**Water Supply Project Eastern and
Midlands Region**

Routing Report

Appendix E - Re-route Request Mapbook

Document no: 32105801/CPORoutingReport/AppendixE

Client	
Project	WATER SUPPLY PROJECT MIDLANDS AND EASTERN REGION
Drawing Title	REROUTE MAPPING
Drawing No.	32105801/300/00001
Drawing Status	FOR REVIEW

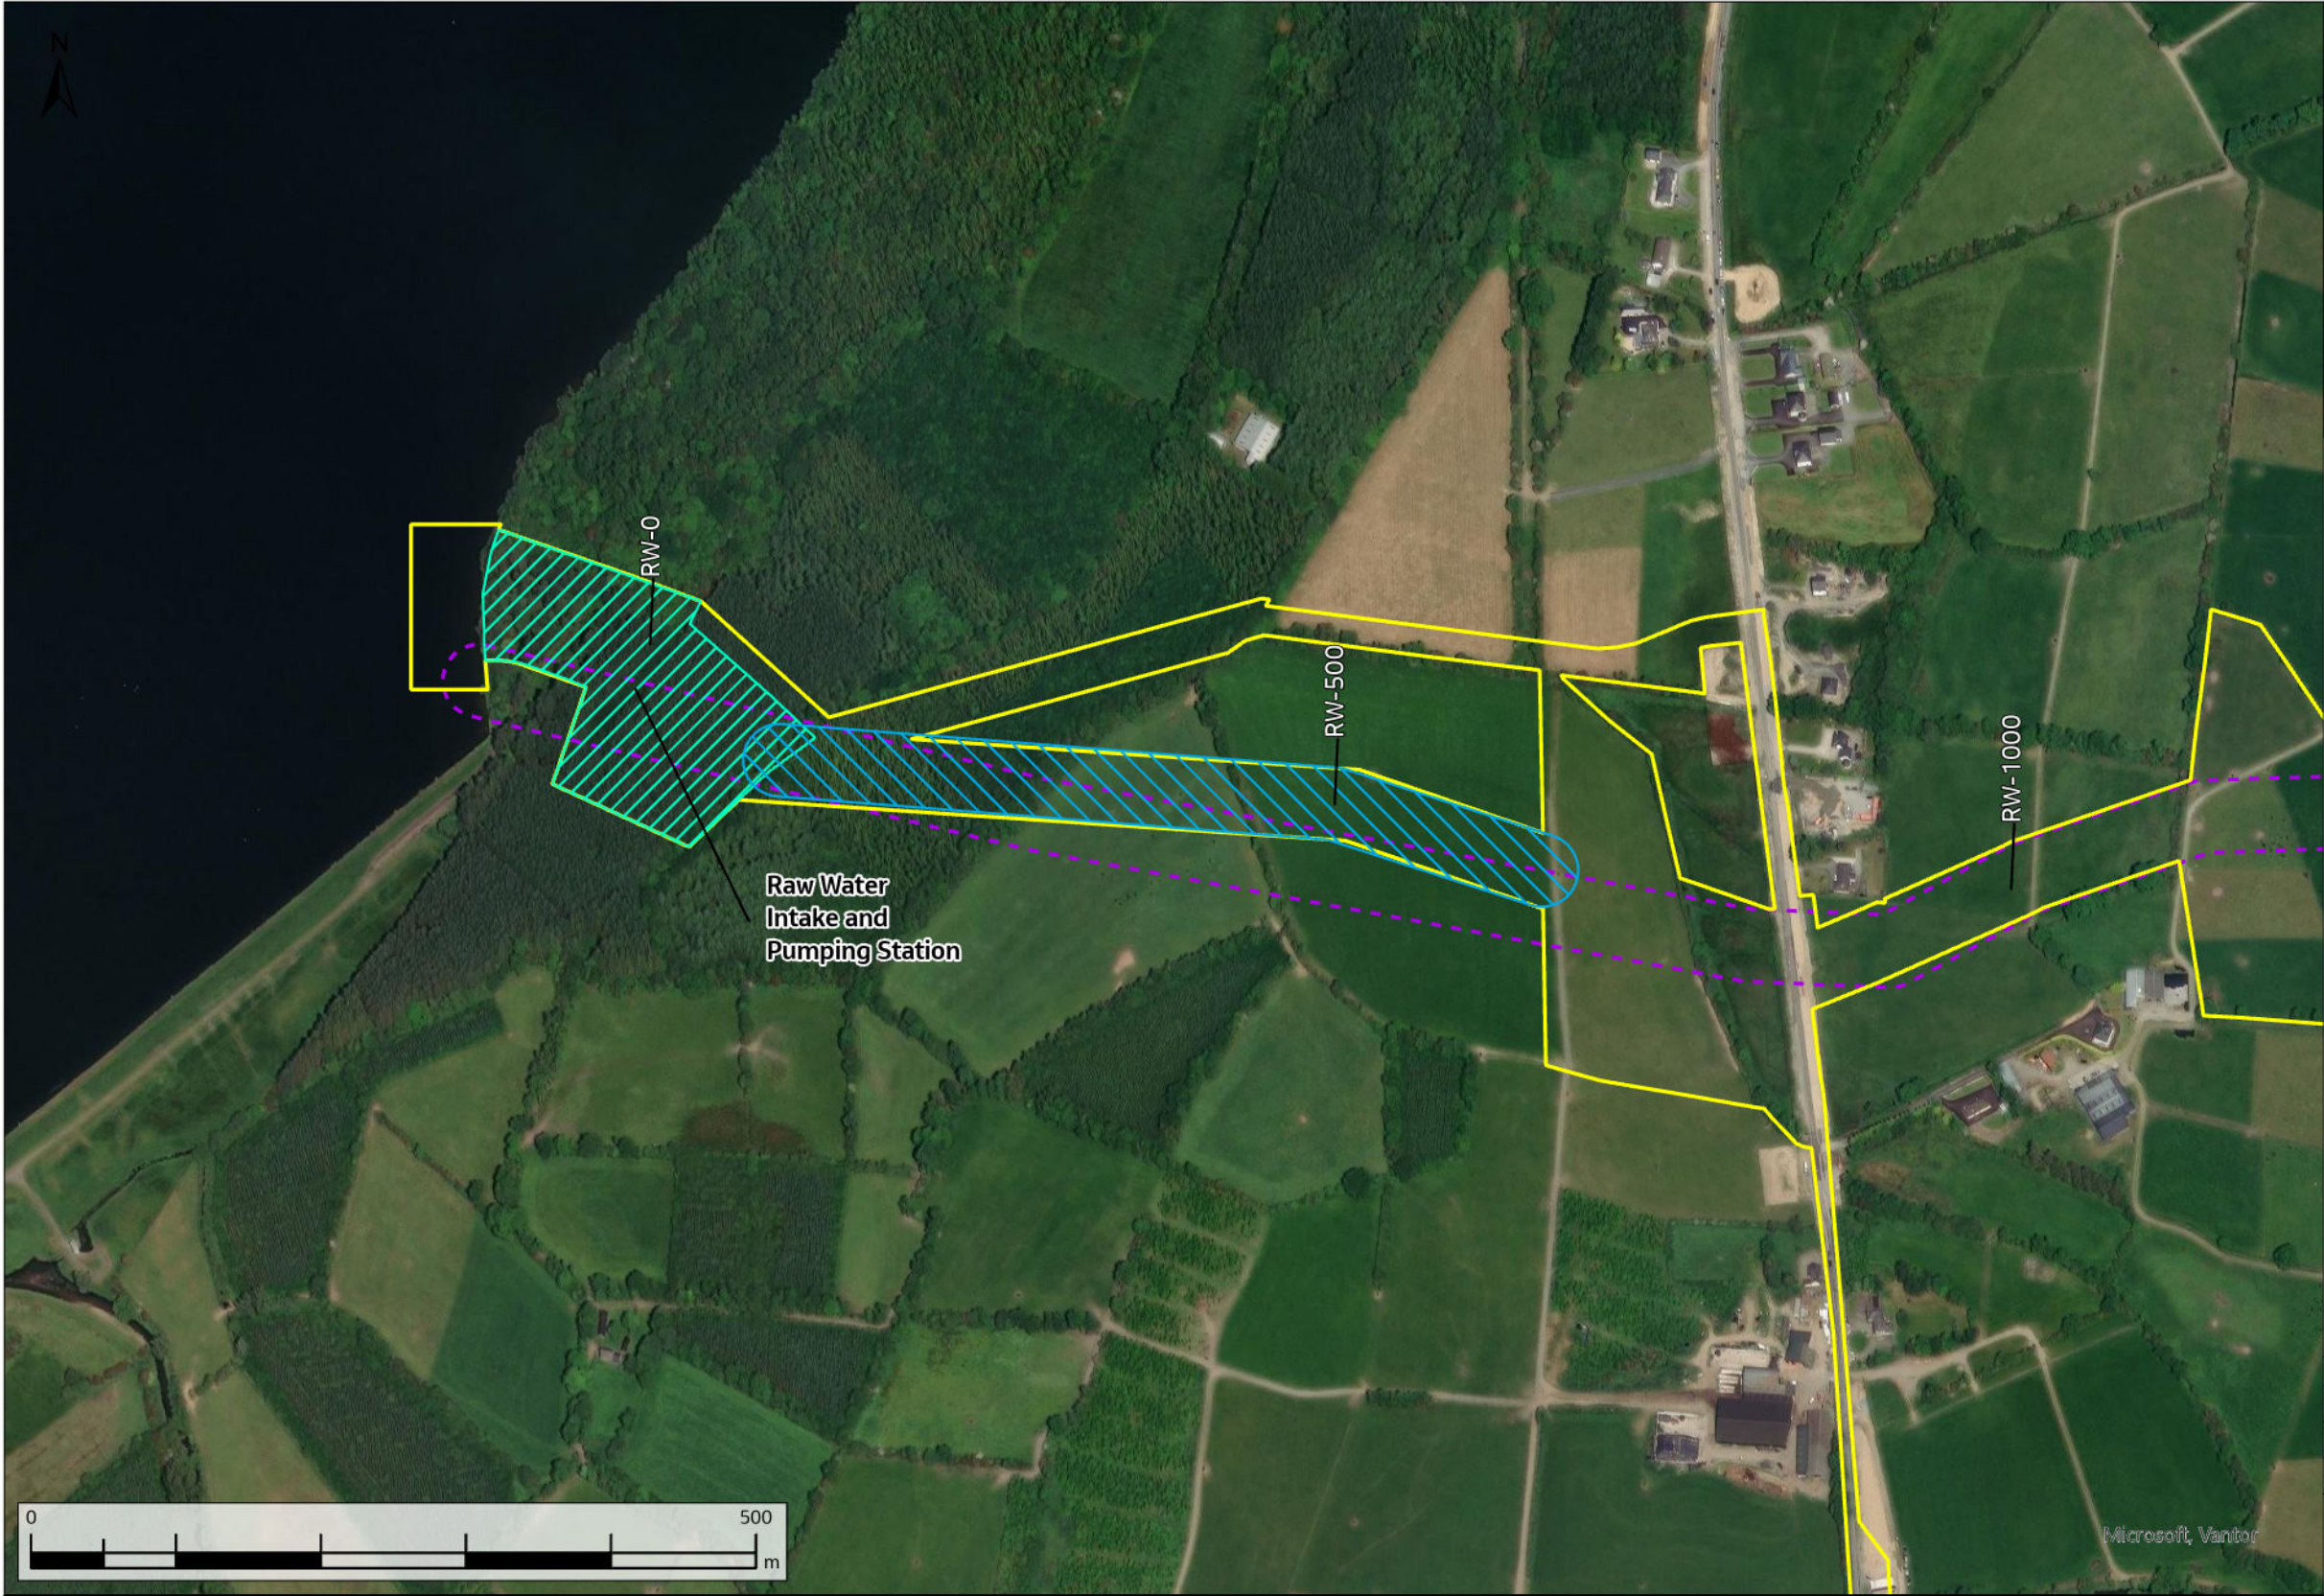
WAYLEAVE	QUERY SUMMARY	ENVIRONMENTAL ANALYSIS	TECHNICAL ANALYSIS	LANDOWNER ENGAGEMENT	DECISION	CLOSING COMMENTS
WL001	Technical Reroute Request - Alignment amendment to the north due to improved topography in order to facilitate construction works.	No environmental objection.	No technical objection.	Landowner has been made aware of the technical reroute.	Facilitated	Request has been facilitated.
RW-500

Client	
Project	WATER SUPPLY PROJECT MIDLANDS AND EASTERN REGION
Drawing Title	REROUTE MAPPING
Drawing No.	32105801/300/00002
Drawing Status	FOR REVIEW

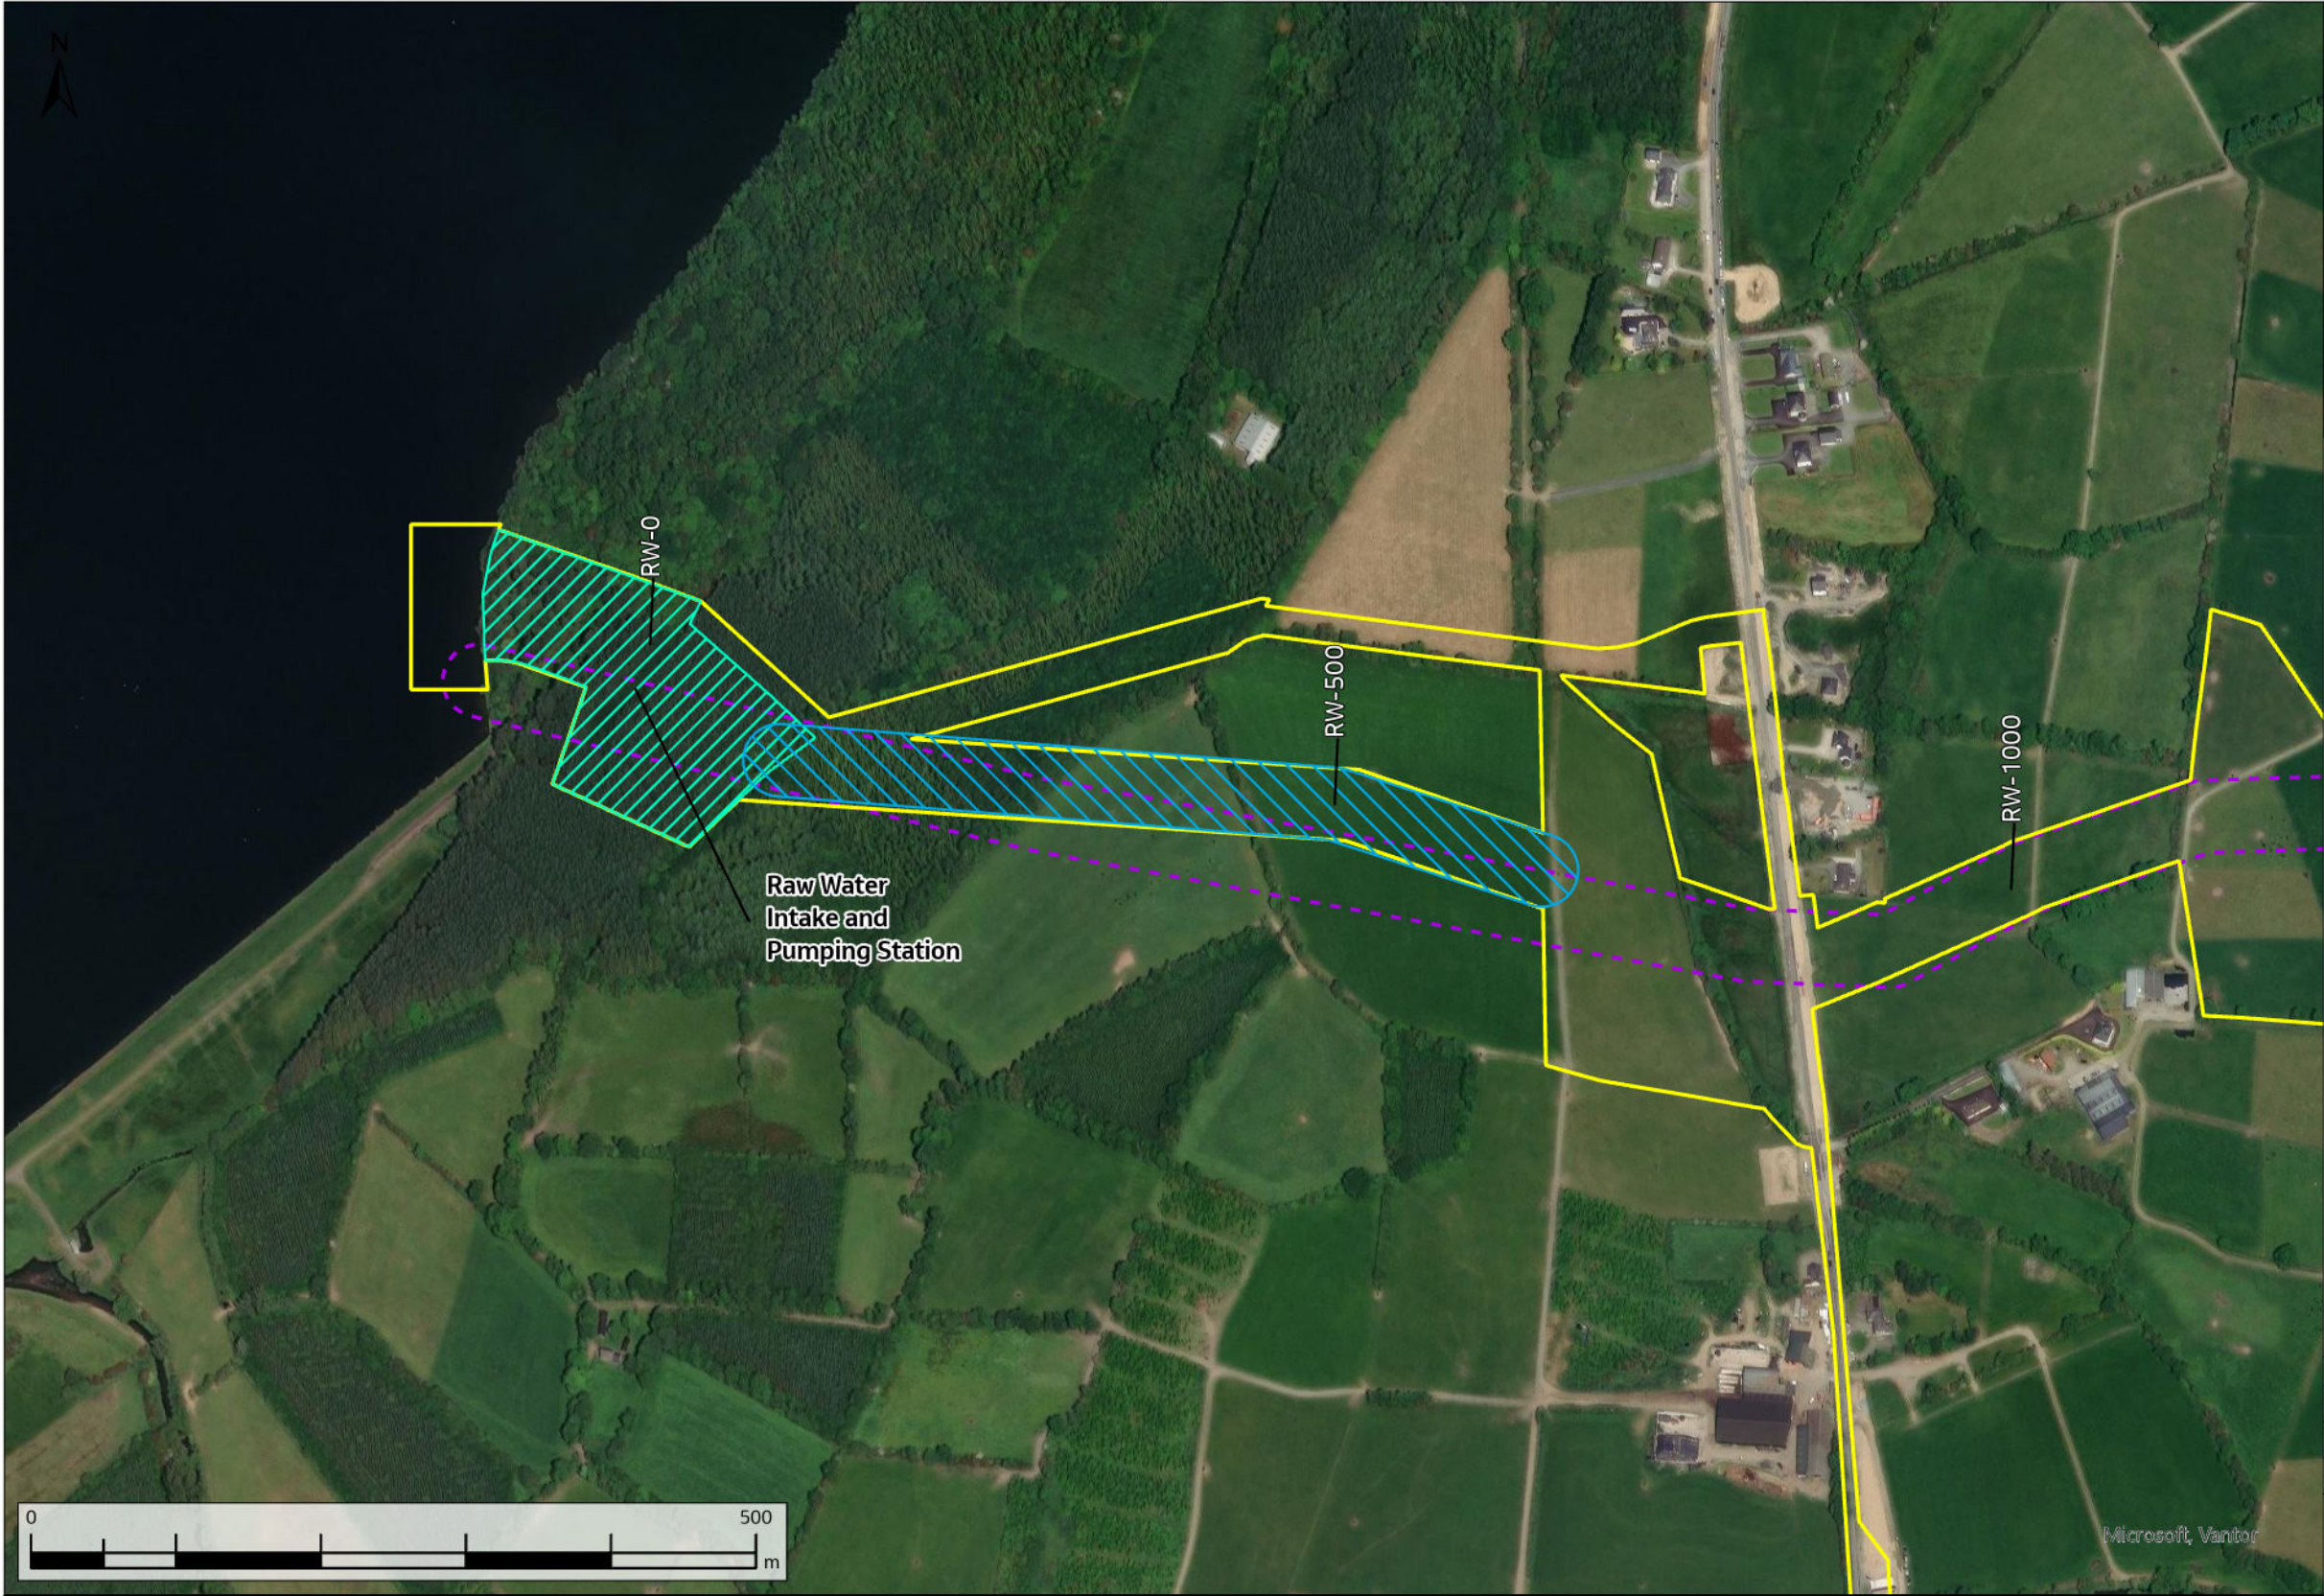
WAYLEAVE	QUERY SUMMARY	ENVIRONMENTAL ANALYSIS	TECHNICAL ANALYSIS	LANDOWNER ENGAGEMENT	DECISION	CLOSING COMMENTS
WL002	Technical Reroute Request - Alignment amendment to the north due to improved topography in order to facilitate construction works.	No environmental objection.	No technical objection.	Landowner has been made aware of the technical reroute.	Facilitated	Request has been facilitated.
RW-500

Client	
Project	WATER SUPPLY PROJECT MIDLANDS AND EASTERN REGION
Drawing Title	REROUTE MAPPING
Drawing No.	32105801/300/00003
Drawing Status	FOR REVIEW

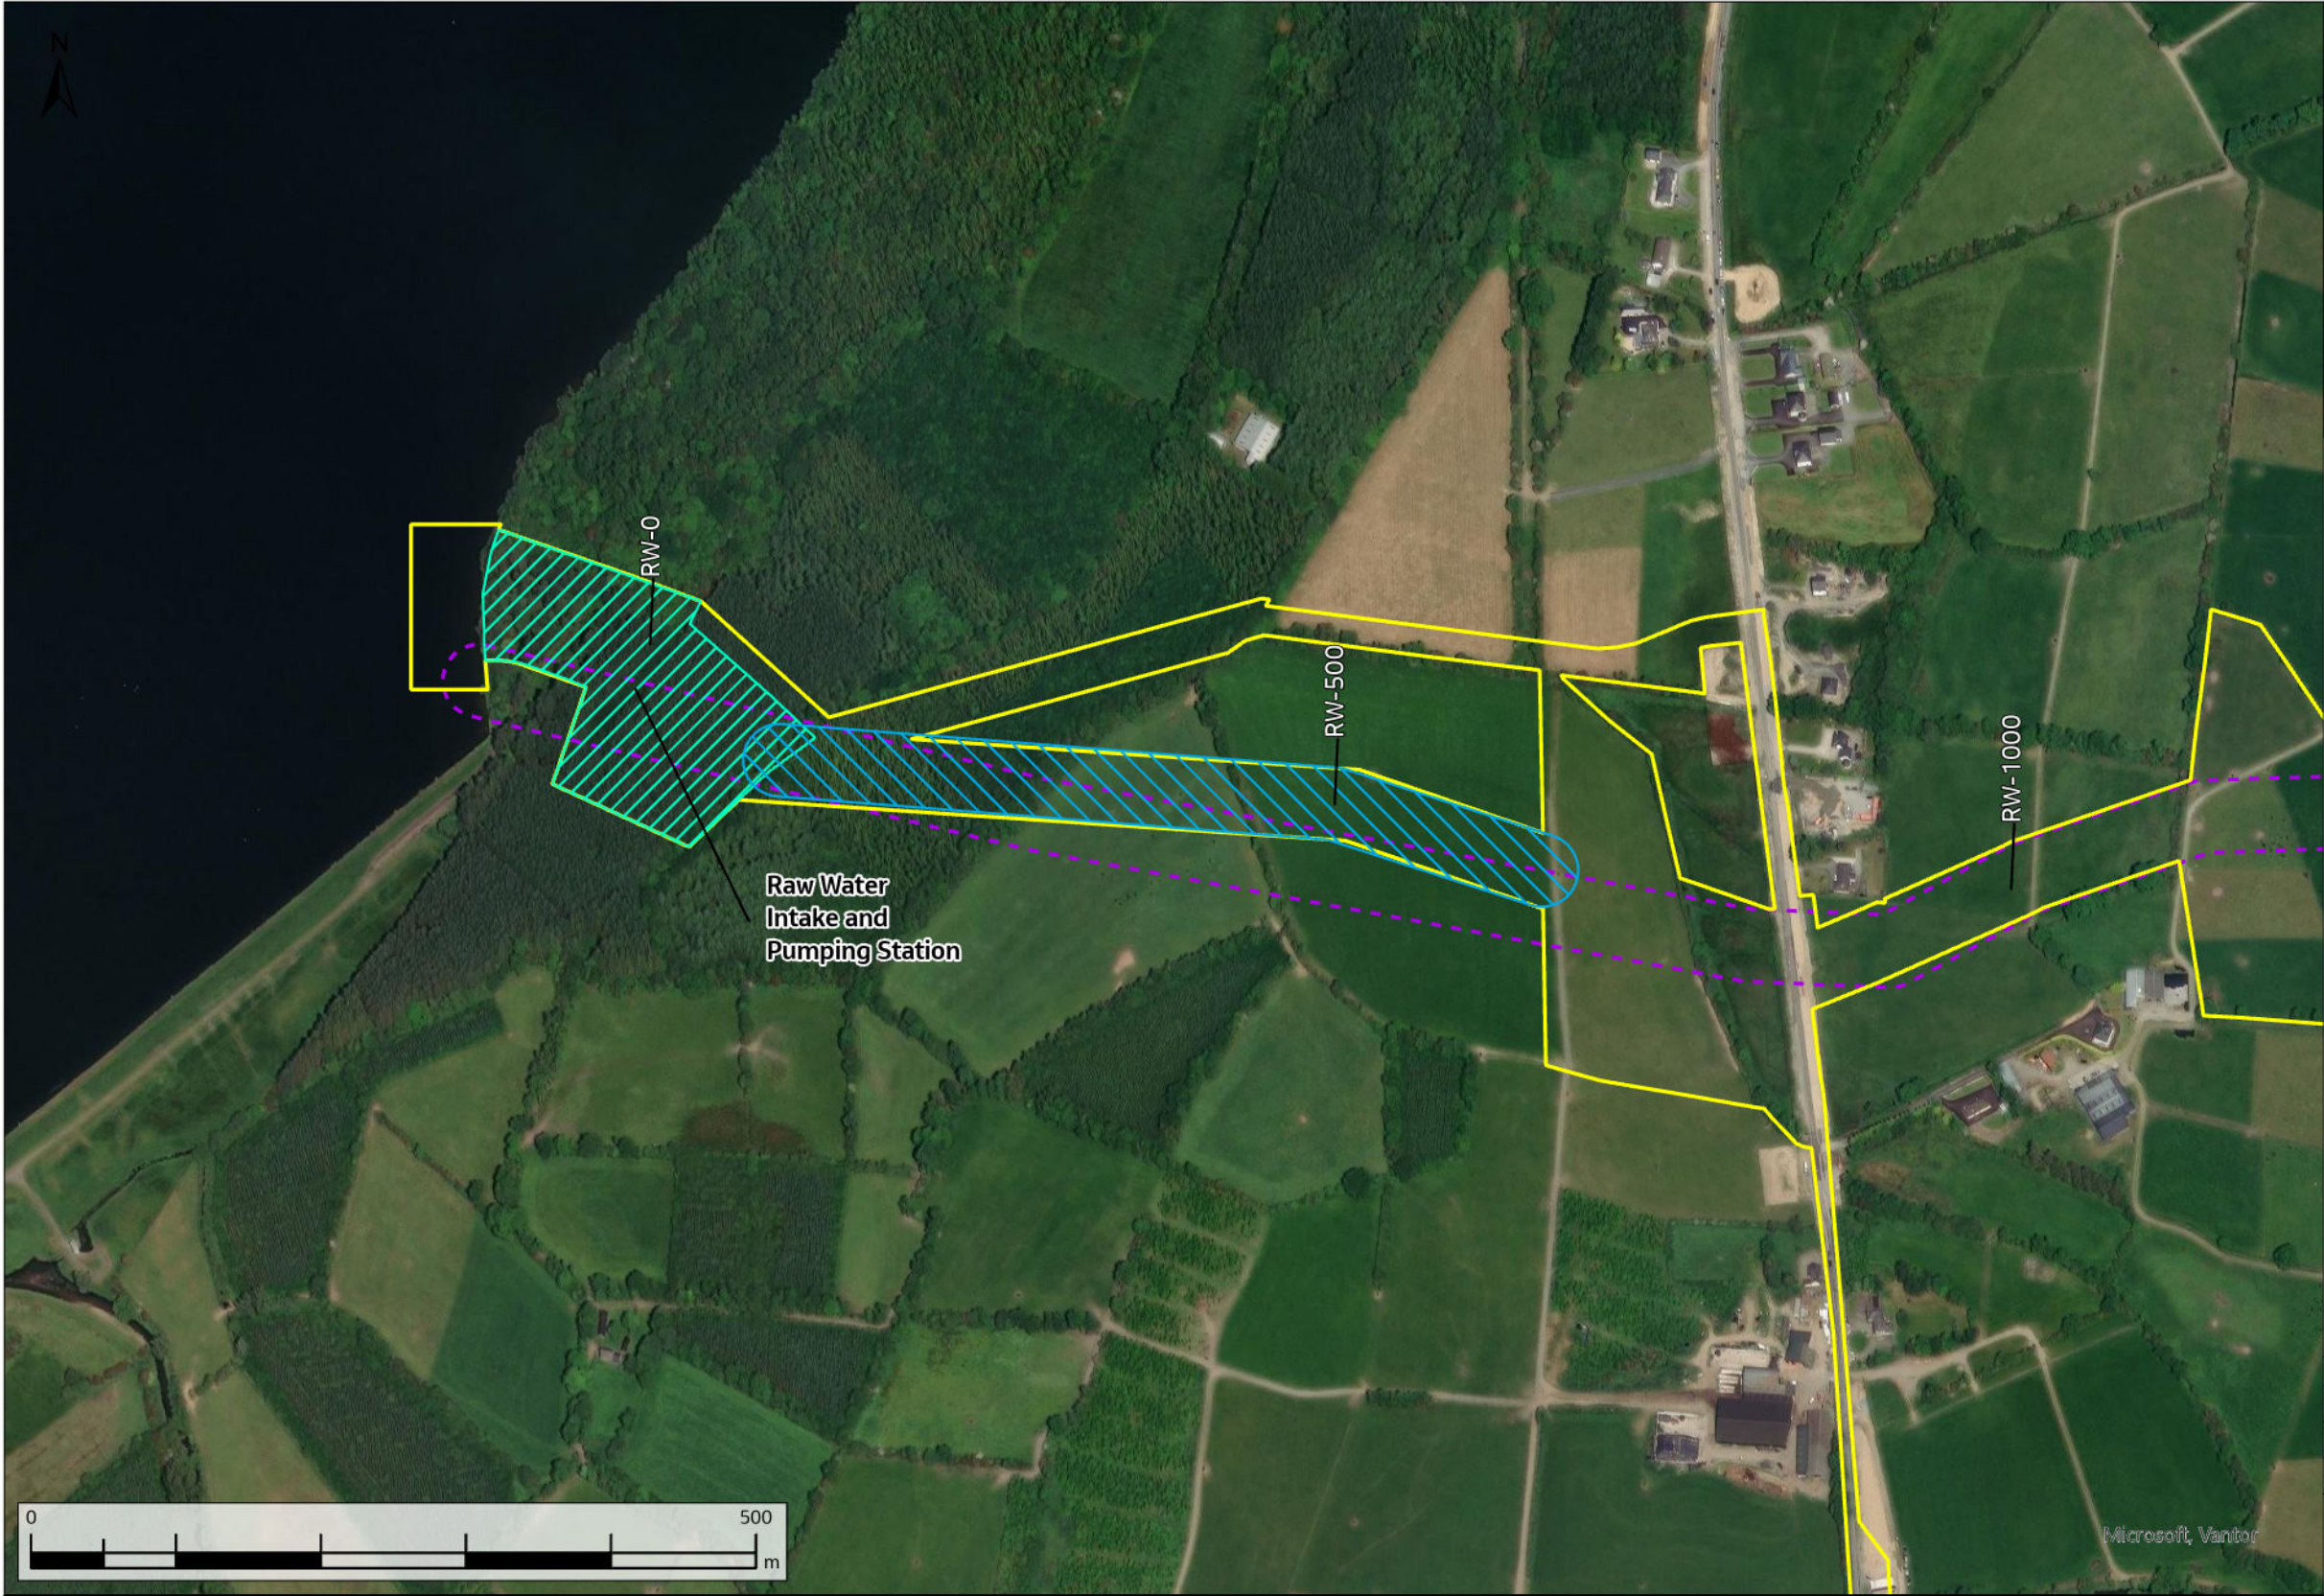
WAYLEAVE	QUERY SUMMARY	ENVIRONMENTAL ANALYSIS	TECHNICAL ANALYSIS	LANDOWNER ENGAGEMENT	DECISION	CLOSING COMMENTS
WL003	Technical Reroute Request - Alignment amendment to the north due to improved topography in order to facilitate construction works.	No environmental objection.	No technical objection.	Landowner has been made aware of the technical reroute.	Facilitated	Request has been facilitated.
RW-500
